URBAN EXTENSION SA4: BROADMOOR HOSPITAL, CROWTHORNE

Landscape Capacity Study

I. ASSESSMENT OF LANDSCAPE AND GAP ISSUES IN RELATION TO THE CONCEPT PLAN

2. RESPONSE TO LANDSCAPE ISSUES RAISED ON THE LANDSCAPE CAPACITY STUDY BY BROADMOOR HOSPITAL, CROWTHORNE

Concept plan from SADPD

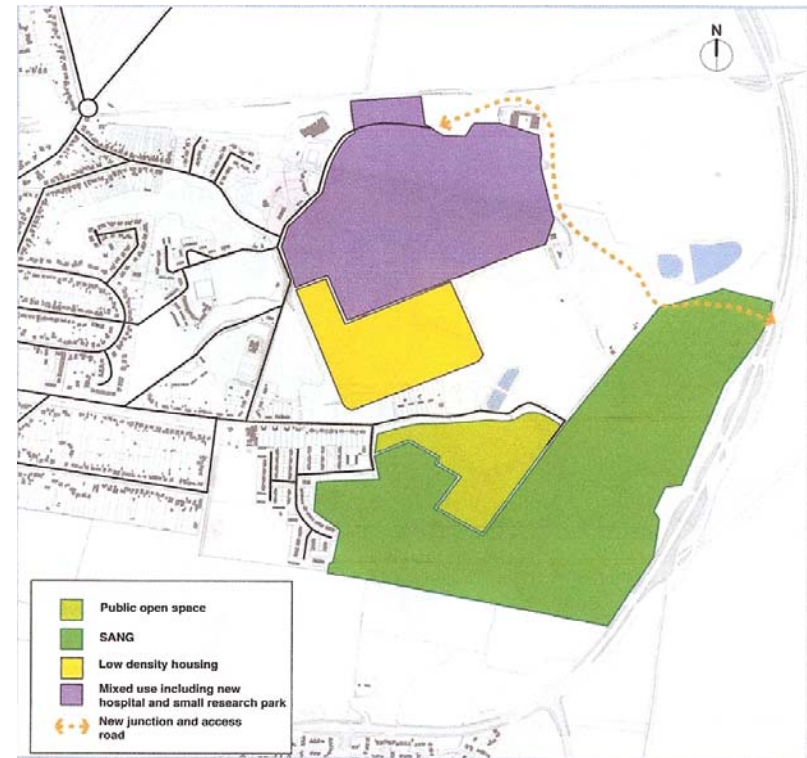
LCS Area/ Development proposal	Feature	Comment on concept plan	Action recommended
Key landscape characteristics Area A: Development Area	Enclosed garden setting to the listed buildings	This is included in the area set aside for mixed use. The masterplan would need to respect and enhance the garden setting, in particular the terraces.	Policy SA4 does not currently include a requirement for Green Infrastructure (GI). A need for GI should be added and requirements to retain and enhance the garden setting to the listed buildings in the GI included.
	Historic garden features	It may be difficult to retain some of these (eg the outdoor toilets) but in principle they should be retained and enhanced wherever possible. This should be included within the Conservation Management Plan.	Include included within the Conservation Management Plan (CMP)
	Historic terraces and kitchen garden	<p>The terraces can be retained and enhanced as part of the overall masterplan. SPA requirements have pushed the proposed housing into the kitchen garden, adversely affecting a nationally designated landscape and extending the built form into what was designed to be a part of the open landscape and an open setting to the terraces and the listed buildings. Once this level of housing has been allocated to the garden, it will be very difficult to resist inappropriate development. There is a fundamental conflict between conservation and enhancement of the kitchen garden, its historic significance and its key features, and housing provision. High walls are a key feature of the area but will be oppressive to new residents. A loss of openness cannot be achieved through provision of private gardens. Housing would also merge the hospital site into the surrounding housing on Lower Broadmoor Road.</p> <p>The listed buildings and parkland are not the only important parts of this historic park and garden and development in the kitchen garden should be given much more careful consideration and alternatives sought.</p> <p>There is a considerable drop (approx. 15m) between the northern boundary of the kitchen gardens and the southern boundary. Below that sit existing 2 storey houses which although not of a high standard of design do not overly intrude into the view. A higher density of built form, with inevitably higher rooflines AOD descending the slope, will be more intrusive.</p>	The SADPD includes housing in this area as enabling development and anticipates that by setting the housing down the natural slope (and lowering levels) will mitigate the landscape, visual and historic impact of the development. Although the proposed density is low, emerging design from WLMHT suggests a solution that compromises the landscape character, visual and historic integrity of the site. A lower density, more imaginative solution, is needed.

Walled enclosure	The walls at Broadmoor are of historic note and are also identified as key features in the Crowthorne Character Area SPD. Some reduction in height to the existing walls may be possible but should be considered in the light of their historic and townscape significance so as to avoid undermining their role at Broadmoor.	Include in Conservation Management Plan (CMP)
Key landscape characteristics Area C: Development Area	Balance of open spaces and woodland	Part of the area included in the concept plan includes the site of the historic cemetery which now has a number of good trees. This area should be excluded from development.	Retain open space of former cemetery within Green Infrastructure requirement in Policy SA4
	Wooded hillsides and tree lines	The cemetery sits on a typical tree covered hillock	Retain area as distinctive tree covered knoll
	Historic approaches and designed features	The WLMHT Masterplan shows the scope to restore historic approaches and to retain designed features	Support restoration of historic approaches and design features

Key landscape characteristics Area B: SANGS and open space	Historic parkland	Only part of the park is shown set aside for SANG or open space. It is essential that the integrity of the park is retained as a whole and managed as one unit. The proposed access route cuts across the park. There is no objection in principle to the proposed routeline, but it is essential that the engineered design of the road is kept to a minimum and fully respects the landscape and historic character of the park. This should include the design of the route alignment, both horizontal and vertical, working with the contours; minimal road width and use of hard features; and landscape integration measures.	Clarify that the requirement for a Conservation Management Plan (CMP) is not confined to the area of SANG and open space and includes the whole of the parkland on the concept plan.
	Open pasture landscape	Retain balance of open pasture to woodland in the parkland. The SADPD does not anticipate the need for any new buildings in Area B. The design and siting of any other facilities (playing fields, car parking etc) would need to be carefully designed to avoid an adverse impact on the parkland.	To be considered in the CMP

Key visual features Area A: Development Area	Long views from the hospital grounds to south and east over parkland	These are from the terraces in the main. Provided the terraces are retained and enhanced, the main impact will be from housing in the kitchen garden. The proposed development in the kitchen garden is likely to have an impact on these views. It is not enough to retain views long distance views alone. Historically, and today, the open walled character of the kitchen gardens allows undeveloped views of the parkland (with only a small level of intrusion from existing houses at the lower level) with the kitchen gardens providing the foreground. Views from the kitchen gardens themselves were a key part of the historic design. See Sarah Rutherford's Historic Landscape Appraisal Feb 2011. Rooflines are likely to have an impact on the existing panoramic views over open spaces into parkland.	See above points

Comment no.	Area /Author (representing)	Response	Comment on response	Recommended action
1	Area B/Boyer Planning (Blue Mountain)	Amend Illustrative Concept plan to clarify whether the 'white area' is allocated for development or other use	The 'white area' is an integral part of the historic park and garden and should be conserved and enhanced as part of the open land. It also falls under open countryside CS9.	Clarify open countryside/parkland status on the Concept Plan

4. Include Green Infrastructure requirement into Policy SA4
5. The Conservation Management Plan (CMP) must accompany any development proposals and demonstrate that any development or land use changes (including playing fields) can be accommodated without harm to the parkland, its topography, vegetation pattern or views

6. Clarify the status of the 'white land' in Area B
7. Add requirement for development to respond to the recommendations of Crowthorne Character Area SPD

Concept plan from SADPD

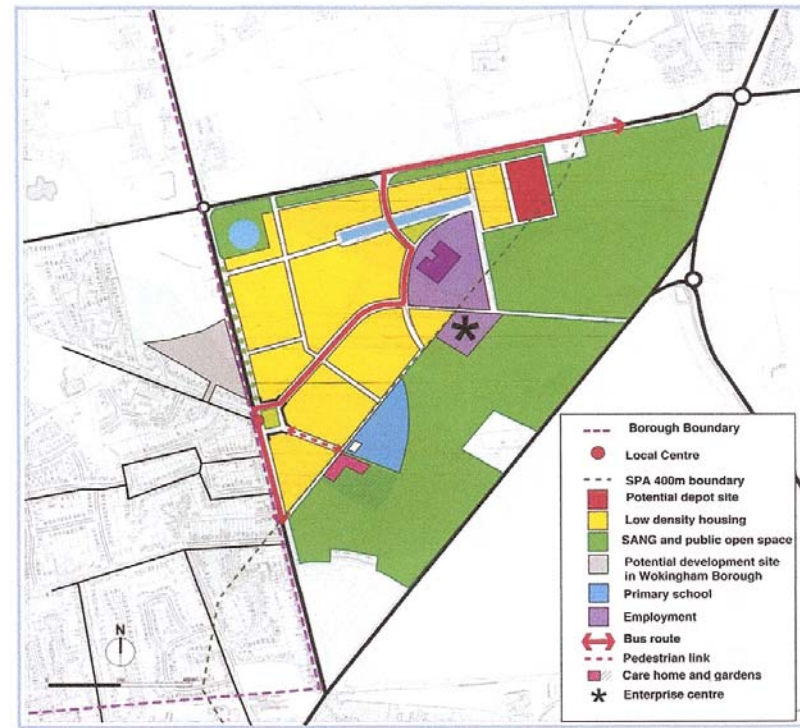
Landscape issue	Area		Comment on concept plan	Action recommended
Key landscape characteristics	C1 (south of Nine Mile Ride)	Continuous forest cover	The eastern area of forest will be partly lost to housing. The resulting green route must be wide enough to properly screen the development and avoid perception of layers of built form when viewed from Nine Mile Ride (see Inspector's report para 771 and 772).	Specify required width of green route in Policy SA5 – min 50m.
		Forest setting to Ride	A narrow forest belt is retained along Nine Mile Road in the eastern part. This must be of sufficient width to retain a forest setting.	Specify required width of green route in Policy SA5 – min 50m.
		Wooded gateway to Crowthorne	An area of forest is shown retained at the junction of Old Wokingham Road and Nine Mile Ride	
	C2	Continuous forest cover	Some existing forest cover will be lost but extensive new forest planting will be possible.	Add requirement that: the net change must not result in the loss of forest cover; and development where possible should be sited to minimise the loss of good quality forest.

B	Area is within Bracknell-Crowthorne strategic gap	The concept plan suggests a larger built footprint than at present. This is partly offset by returning the tarmac areas to forest in C2 but the tarmac areas currently do not detract from the physical and visual separation of the two settlements. It is intended that SA5 would be designed as an extension to the settlement of Crowthorne within Wokingham Without, reflecting the local character of that settlement.	Development within Area B to be well integrated with Crowthorne, allowing for a tree lined frontage to Old Wokingham Road.

Comment no.	Response	Comment on response	Recommended action
R1	Development will erode gap between Bracknell, Wokingham and Crowthorne	The Appeal Inspector and SoS did not rule out development within SA5 and some increase in the footprint was accepted in principle. However it was made clear that the remaining gap must be able to properly serve its function in providing both a physical and visual separation between the settlements. See comments in section I and recommendations.	
R2	The strip of woodland along Nine Mile Ride is insufficient to maintain the gap	SA5 is diagrammatic but it very important that the strip is wide enough to contribute to the functions of the gap. For this reason it is recommended that a minimum width is included in Policy SA5 – see comments in section I.	
R3	A belt of trees should be provided along Old Wokingham Road	Agreed. This is illustrated in the concept plan and should be included in a Development Brief.

2. Omit development in SANG in the north-west corner.
3. Specify required width of green route in Policy SA5 – min 50m
4. Revise strategic gap boundaries to omit the urban extension but include SANG/open space areas

Concept plan from SADPD

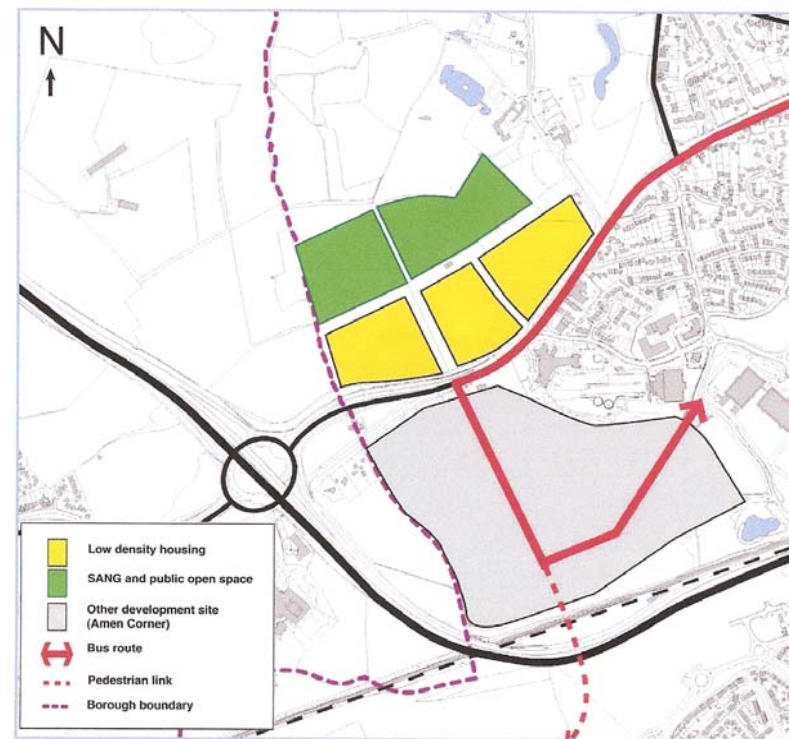
Landscape issue		Comment on concept plan	Action recommended
Key landscape characteristics	Open rural landscape between Binfield and Bracknell	The majority of the open rural area remains as open rural land with only that part already heavily influenced by development on London Road (and to be developed at Amen Corner South) proposed for housing. The retention of Popes Manor as a substantial area of open ground is important to prevent the proposed housing merging with Binfield along London Road.	Add note on Popes Manor.
	Open rural landscape between Wokingham and Bracknell	The proposed housing area will affect the perception of the open rural landscape gap along London Road. Once Wokingham's Strategic site south of the A329 is developed, the land between the A329 and the Urban Extension will need to be maintained as the remaining open rural land between two major settlements. The proposed housing does not extend further west than Amen Corner South.	A strong woodland belt 25m wide linking to the copse in Wokingham, and to Pocket's Copse, should be provided to conclude the western edge of the housing area. This should be added to the green infrastructure requirements in Policy SA6. Include requirement for a detailed landscape masterplan.

Visual prominence of Pocket's Copse and Blackman's Copse	Uninterrupted views of the two copses from London Road will be lost. Other views are unaffected	Detailed design of the area should allow for vistas to the copses through the development. Tree cover to remain as the skyline feature.
Other aspects	Poorer landscape condition of southern part of Area A2	Development restricted to this area	
Scope for visual mitigation	Enhanced boundary treatment	No mention of green infrastructure requirements in Policy SA6. Landscape masterplan must include woodland planting proposals for the land south of Murrellhill Farm and east of SANG to link the two wooded areas in order to protect the open landscape north at this point.	Add green infrastructure requirements to Policy SA6.
	Retain existing trees and hedgerows	No mention of green infrastructure requirements in Policy SA6	Add green infrastructure requirements to Policy SA6.

Comment no.	Area	Response	Comment on response	Recommended action
1	General	Para 1.5: Development of Amen Corner North with Amen Corner South will create better gateway into Bracknell	There is scope for improvement to this northern approach to Bracknell. The detailed design of the green infrastructure and built form will need to be carefully considered to achieve this objective.	Add requirement to policy SA6.
2	Concept	Para 1.6: Amend plan to show SANG/open space	Supported.	Amend plan as

R8	The development will create a Parish with 3 distinct communities, diluting the identity of Binfield and Popeswood	See comments under R6. The masterplan and landscape masterplan should draw on the key characteristics of Popeswood South as well as the emerging proposals for Amen Corner South in order to respect the local landscape and townscape character of Binfield. See also section I under Gap Issues.	Add to design brief for SA6.
R9	No consideration has been given to the local heritage	The Landscape Capacity Study took into account the heritage assets of the village. The importance of protecting the setting of Popes Manor is recognised and therefore it is recommended that a minor amendment is made to the eastern point of the Urban Extension. There will be no impact on proposed Wicks Green Conservation Area.	Slight amendment to the Concept Plan – see summary.

2. Revise strategic gap boundaries to omit the urban extension but include SANG/open space areas
3. Add Green Infrastructure requirements to Policy SA6
4. Strengthen the containment of the Urban Extension and robustness of the remaining gap between Bracknell and Wokingham

5. Strengthen the gap between Bracknell and Binfield in the location of Popes Manor through a slight amendment to the Concept Plan. In order to maintain the separate identity of Character Area C Popeswood South, the southern triangle at the most eastern end of SA6 could be pulled back inline with the south-western tip of Area C and the eastern edge of the proposed SANG.

Concept plan from SADPD

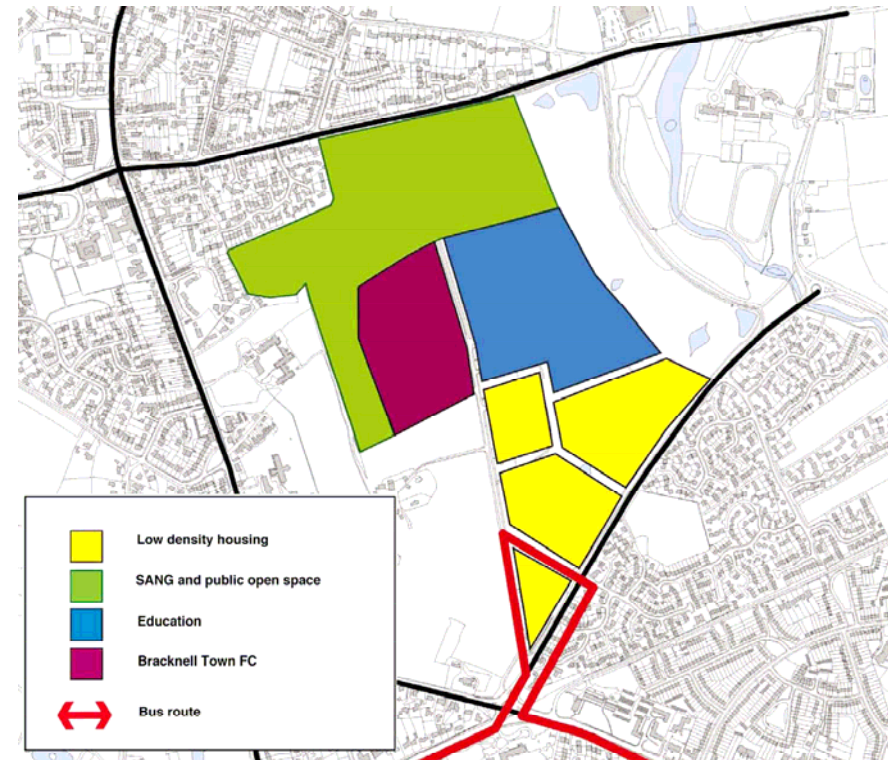
Landscape issue		Comment on concept plan	Action recommended
Key landscape characteristics B1	Protection of individual landscape features	This can be achieved through the landscape masterplan.	Add green infrastructure requirements to Policy SA6.
	Landscape setting to The Cut	The housing and education areas are set back away The Cut. The landscape treatment of this edge should reflect the rural character of The Cut landscape corridor. [This has not be achieved in Luff Developments Ltd plan CSa/1597/105/C]. The design of the SANGS/open space should complement the landscape character.	Add green infrastructure requirements to Policy SA6. Include the land between SA7 and The Cut itself within SANG/open space.
	Open landscape to Binfield village	The immediate open landscape east of Binfield and approximately half of the open land will be maintained. Open land as part of the FC and educational areas will contribute to the remaining openness of the area. CSa/1597/105/C shows that housing will allow small areas of open space but the built up area will affect the open landscape. For this reason the extent of the housing needs to be limited to that shown on the Concept Plan.	Landscape masterplan to include green space and green links to mitigate the impact of the built form.

Comment no.	Response	Comment on response	Recommended action
1	Para 3.5.1: The site can accommodate 900 houses without compromising the gap between Binfield and Bracknell	Plan CSa/1597/105/C shows the housing extending northwards along the eastern side of the site to within 102m of Forest Road. The Concept Plan however shows the SANG extending around 275m from Forest Road and housing to within 500m. This reflects the minimum needed to retain an open landscape in keeping with the local character and maintain the separate identity of the settlements. Allowing housing closer than 500m will therefore diminish the function of the gap. The area of housing provision therefore should not be exceeded. As mentioned in section 1 above the amount of built form in the FC and education areas must also be designed to maintain the function of the gap.	No increase in the area allocated for housing.
2	Para 3.5.2: The open area to the north and west will protect the setting of listed buildings, the historic park and garden	Agreed - See also comments under section 1.

1. Maintain the limit of development to that shown on the Concept Plan
2. Define a suitable balance of open space to built form in the FC and educational areas in order to sustain the openness of the gap

3. Omit small area of western sector of housing closest to Popeswood South southern triangle
4. Revise local gap boundaries to omit urban extensions but include SANG/open space areas
